MSC APOLLO 13 INVESTIGATION TEAM

FINAL REPORT

PANEL 5C

CORRECTIVE ACTION STUDY
AND IMPLEMENTATION

FIGURE 1

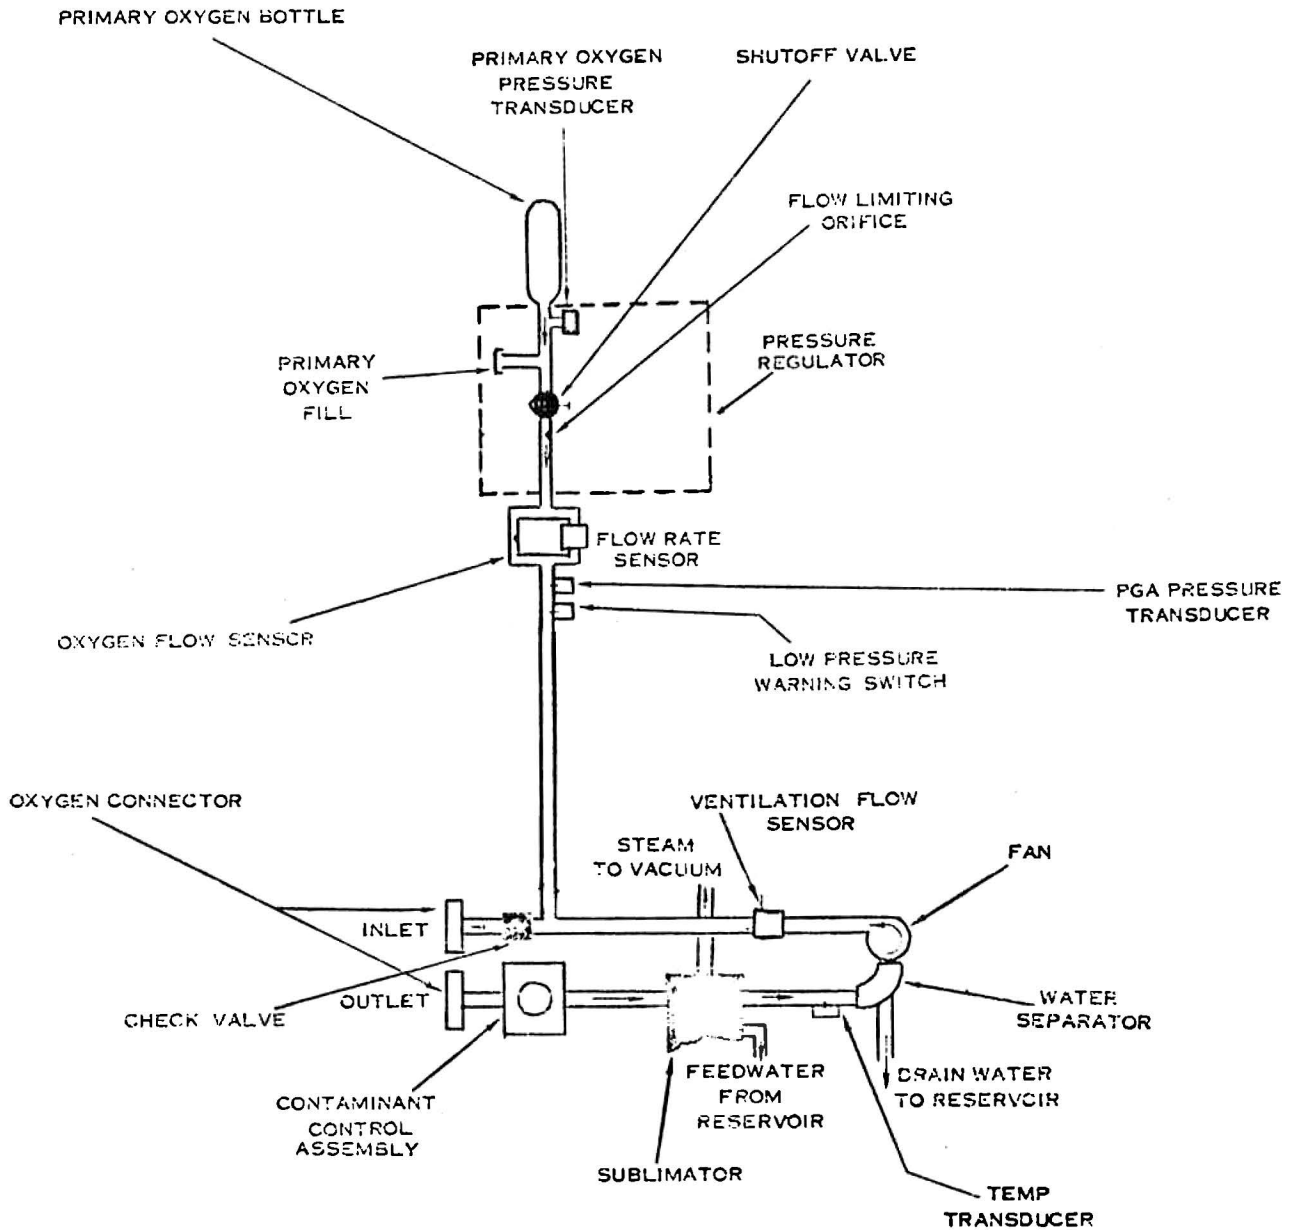
PLSS Criticality I single point failure modes consist of rupture (explosion) of the primary oxygen supply (POS) bottle causing damage to the crewman or the rupture of any element in the oxygen ventilation circuit resulting in premature loss of the oxygen supply (see Figure 1, page 8). Note that blockage of the ventilation circuit or inadvertent disconnection of a PLSS umbilical connector are not considered Criticality I failure modes because of the backup protection of the Oxygen Purge System (OPS) and the incorporation of self-sealing connectors in the PGA.

The ventilation circuit single point failure mode was incorporated into the PLSS because elimination would require a redundant ventilation circuit, redundant PGA interfaces, and complex crossover valving which would yield unacceptable weight and volume growth and an increase in potential failure points. The failure mode has been accepted due to the reliable nature of the system components and the extensive, stringent qualification and pre-flight testing program to which the equipment is subjected. There have been no instances recorded of incipient or actual failure in this mode of the PLSS ventilation circuit.

The PLSS primary oxygen supply bottle failure mode was accepted in the basic design because no other means was feasible, within weight/volume limitations, for the application. Qualification test results indicate that the bottle design provides an actual safety factor of 2.1, based on the ratio of the lowest actual burst pressure recorded during test to the maximum operating pressure possible during mission conditions. The PLSS structure plus an internal shield protects the bottle from damage from external sources during pre-flight handling and during the mission. There are no potential external or internal electrical current inputs to the oxygen bottle. No failures of the PLSS oxygen bottle have occurred.

FIGURE 2

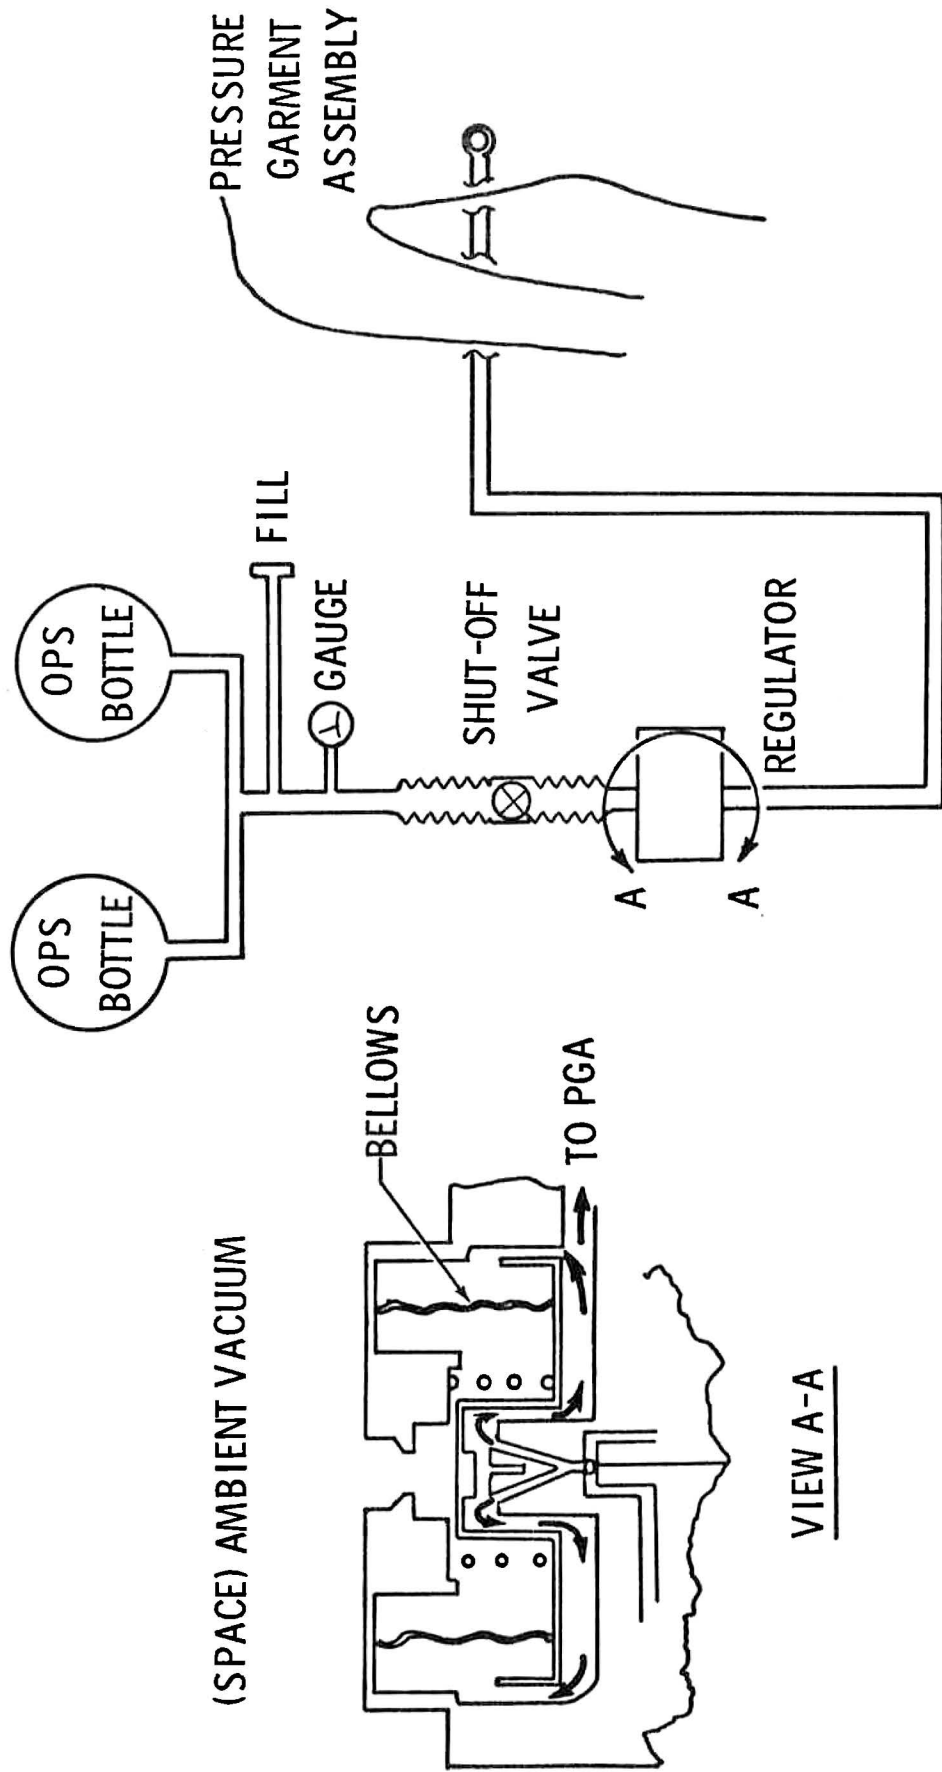
The Criticality I single point failure modes of the OPS consist of explosion of the oxygen bottle causing damage to crewman or equipment, massive rupture of the flow regulator primary bellows permitting oxygen flow out of the suit through the OPS umbilical to vacuum, and rupture of the OPS umbilical again permitting oxygen loss (see Figure 2, page 9).

The OPS regulator primary bellows rupture failure mode was accepted during OPS design due to the complexity of the equipment required for elimination. The added complexity would add several single point failures of a lower criticality and lead to lower overall equipment reliability. Component testing of the bellows indicates an actual safety factor of more than 10.0. This has been borne out by an extensive qualification test program. Each flight unit is also thoroughly tested at the component, subsystem and system level prior to commitment to flight. There have been no instances of failures recorded against the bellows.

The OPS oxygen umbilical design has been accepted for the same reasons as the PLSS umbilicals. No failures have been detected during any test to this point in the program.

FIGURE A2

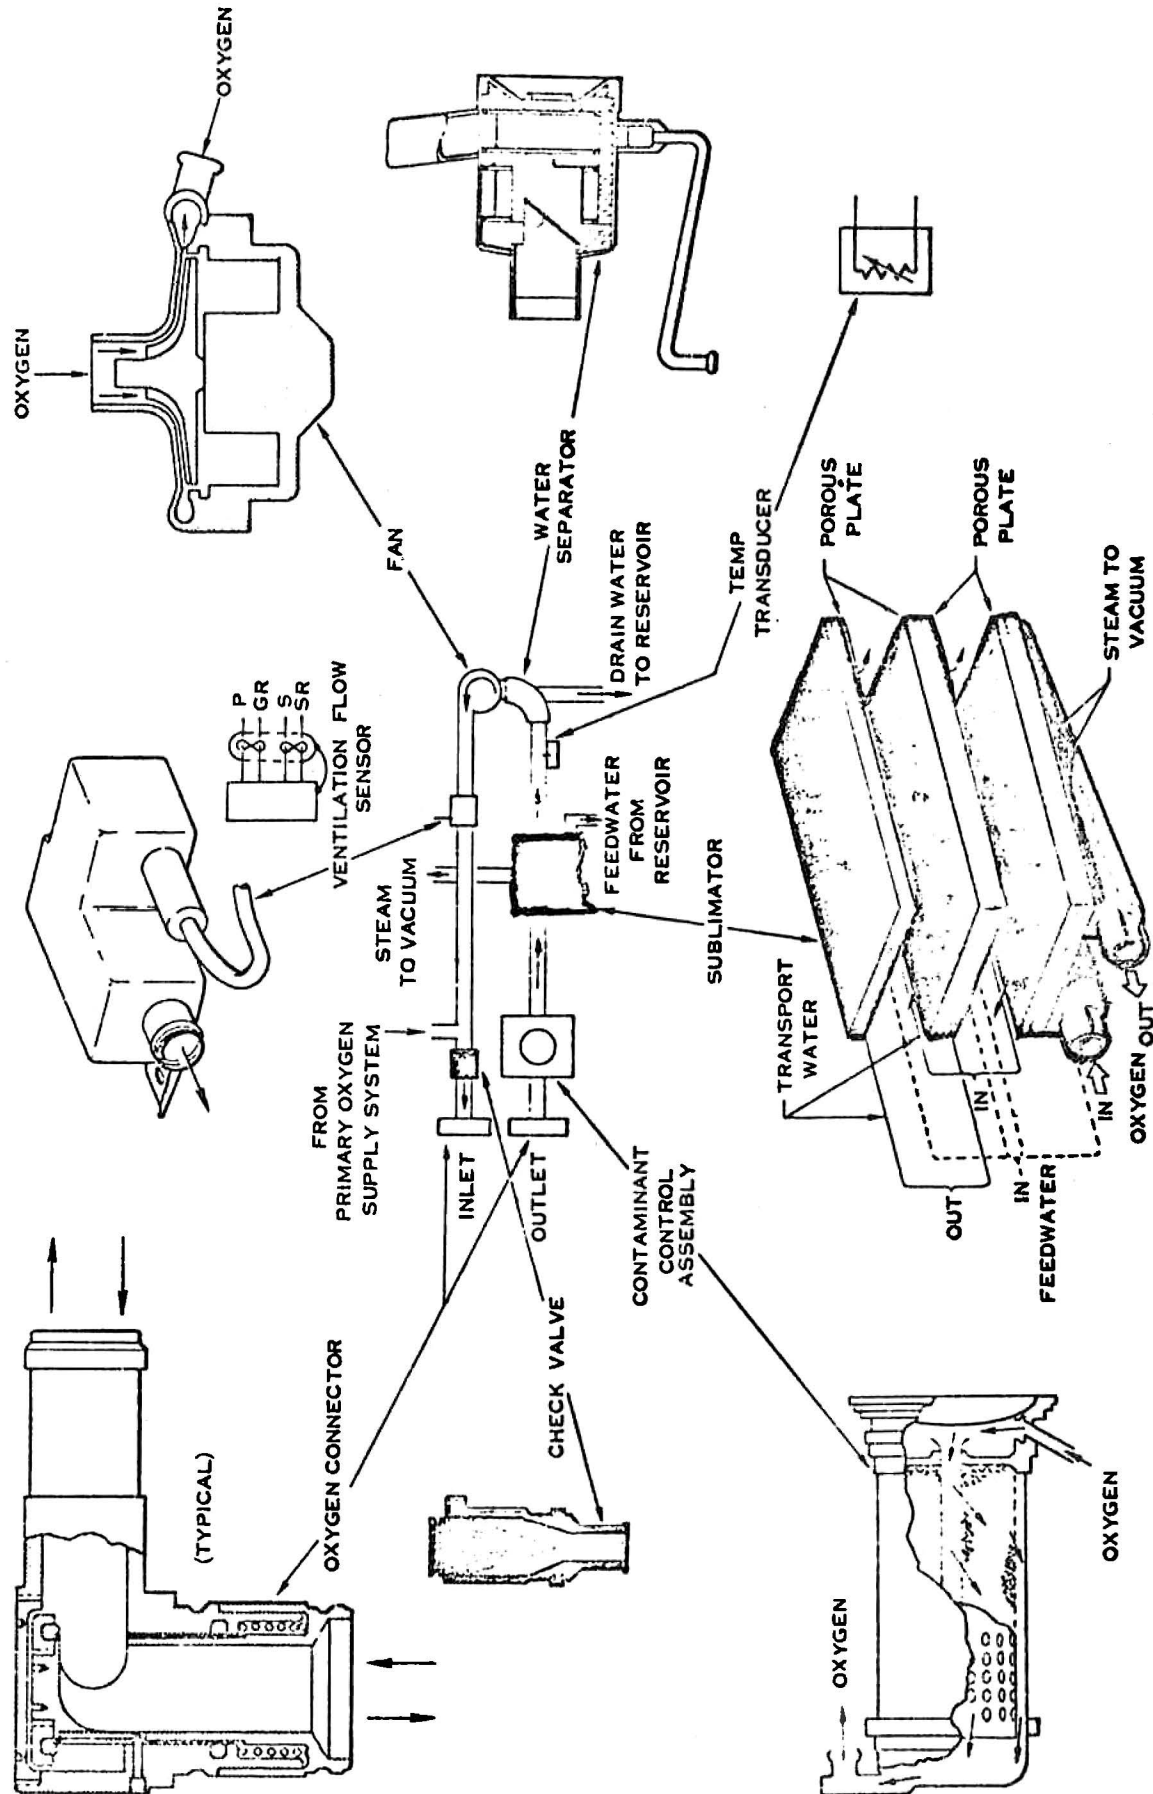
ITEM: PLSS O₂ Ventilation Circuit (see page 39)

FAILURE: Gross Leakage (8#/hour:equivalent to $\frac{1}{4}$ inch hole in suit bladder)

EFFECT: Early Depletion of Prime and Backup O₂ Supply

WHY SPF PRESENT: Elimination would require redundant ventilation circuit and PFA interfaces plus complex crossover valving yielding excess weight and volume with increase in potential failure points.

Design: Umbilicals have inner pressure wall plus fabric wrap and wire reinforcing. All component connections are bonded and clamped. Seal usage reviewed for requirements. Only components exposed to external damage are PFA umbilicals which are covered with beta cloth enclosed thermal sheath which provides abrasion protection. Internal plumbing is metallic. Umbilical axial load requirements set at 60 pounds minimum.

RECOMMENDATION: No Change Required.

FIGURE A3

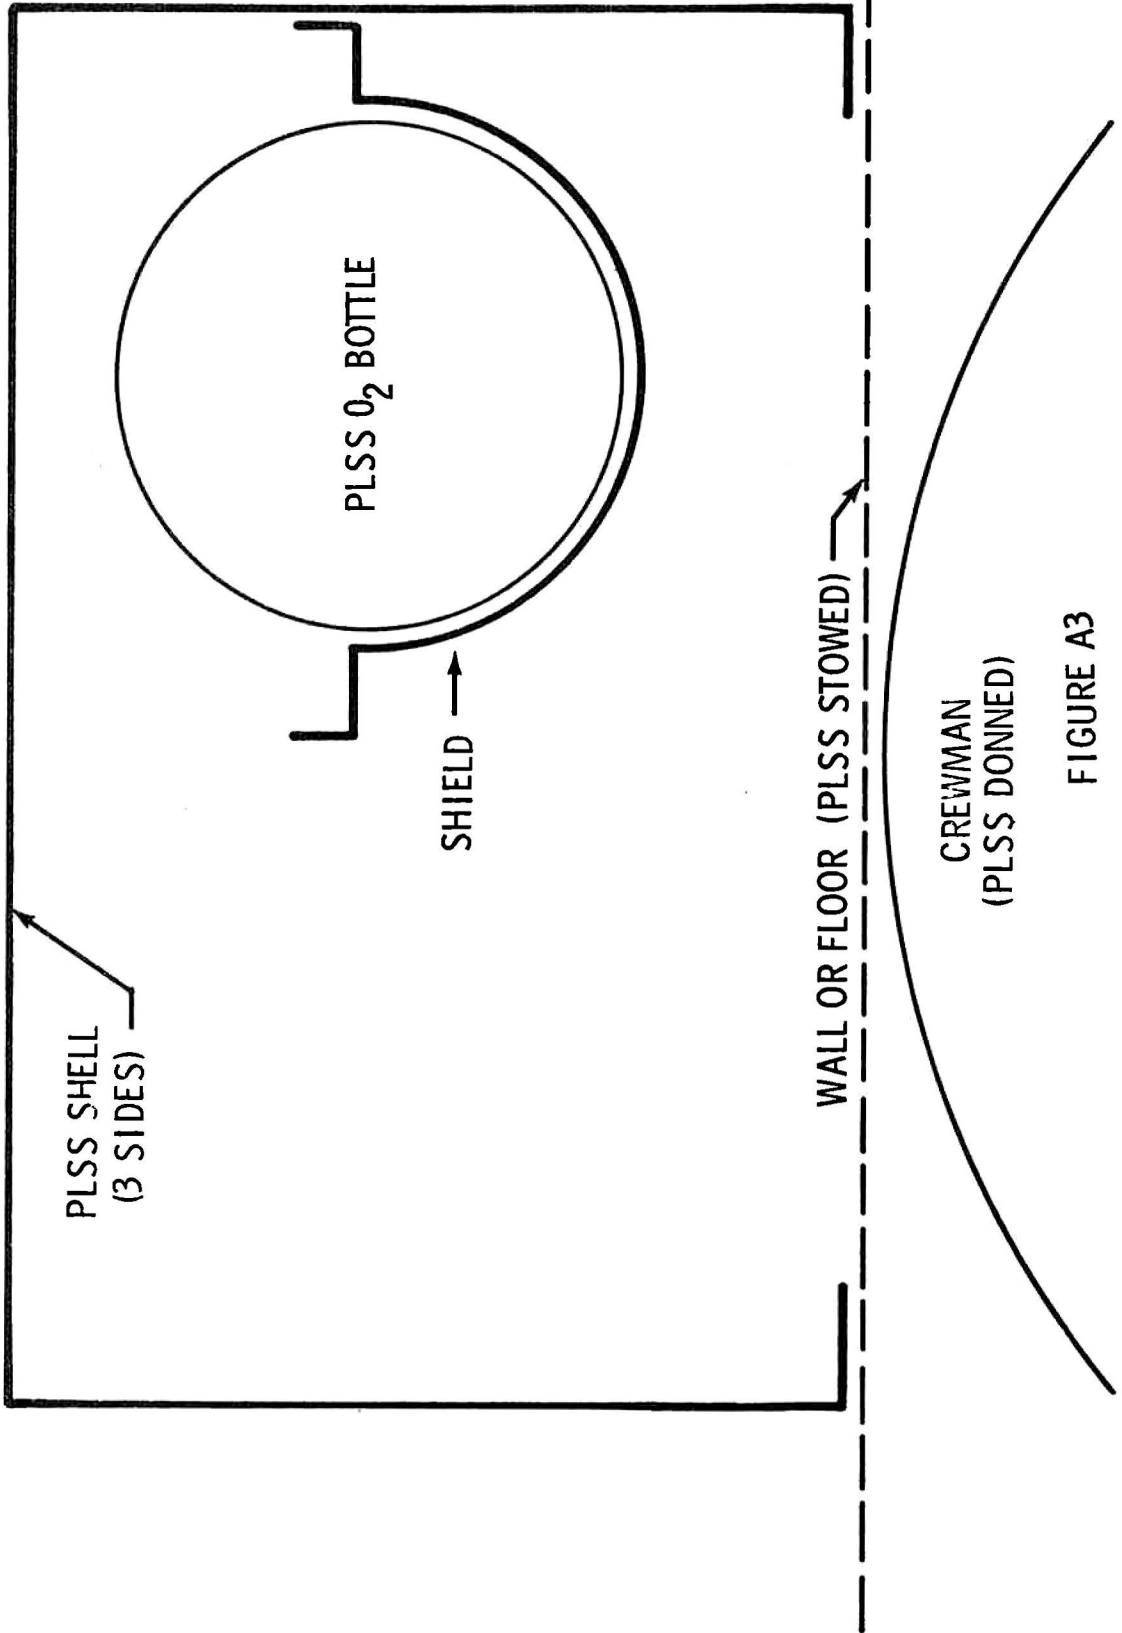
ITEM: PLSS Oxygen Bottle (See description, pages 42 - 44).

FAILURE: Rupture (Explodes)

1. No other means presently feasible for required application.
2. Incorporation of scatter shield would require excessive weight and volume.

Design: Reference Page 42 for physical data on POS bottle.
Reference Page 44 for protection of PLSS O₂ bottle from external damage.

RECOMMENDATION: No change in bottle design or plumbing.

NOTE: -7 PLSS Bottle changed to approximately 1400 psi operating pressure. Requalification test program will assure reliability retention.

FIGURE A4

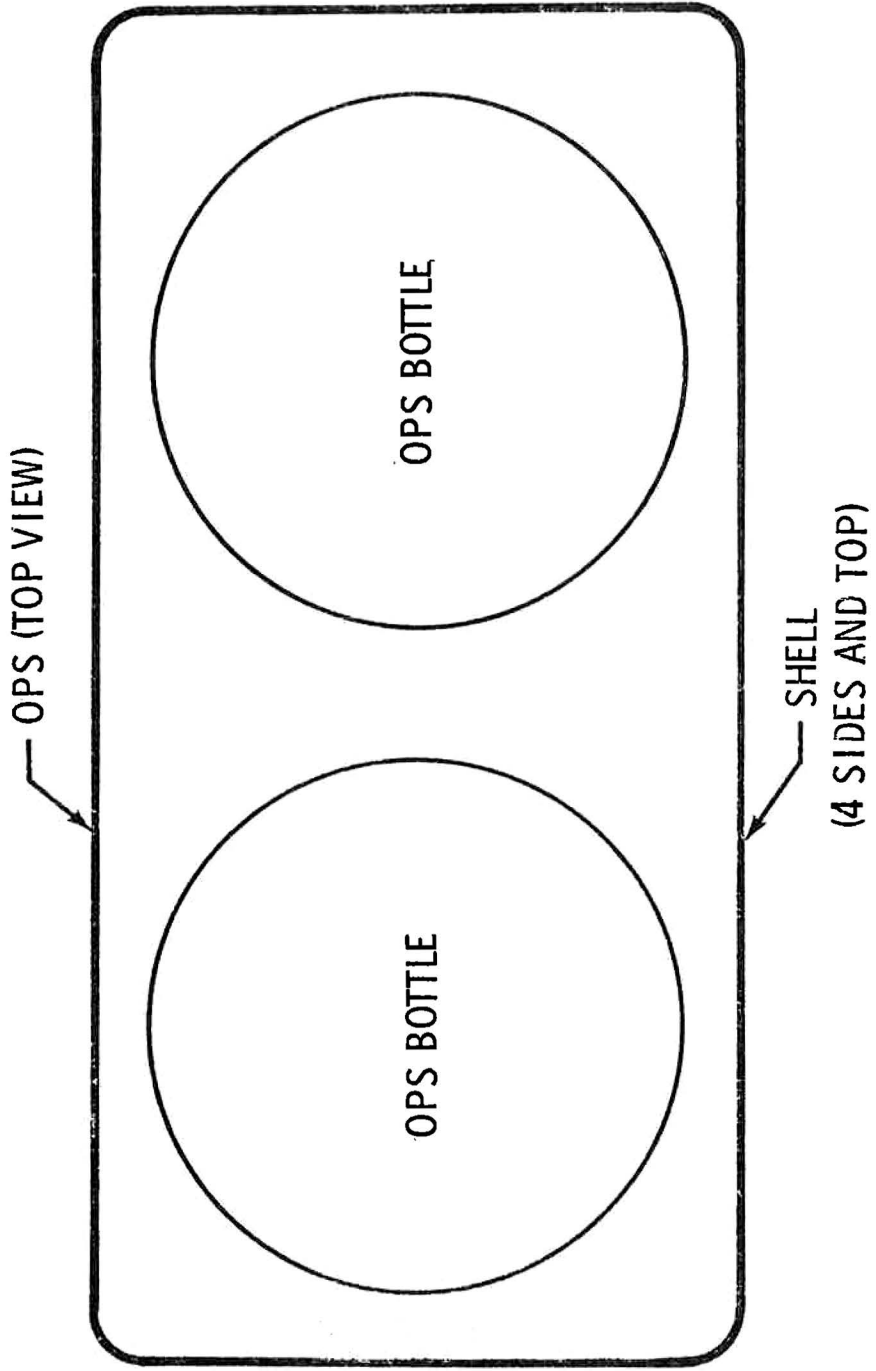
ITEM: OPS Bottle (see description pages 46 & 47).

FAILURE MODE: Rupture (Explodes)

WHY SPF PRESENT: (1) No other means presently feasible for required application.

Design: Reference Page 46 for physical data on OPS bottle.
Reference Page 47 for protection of OPS O₂ bottles from external damage.

Recommendation: No change required.
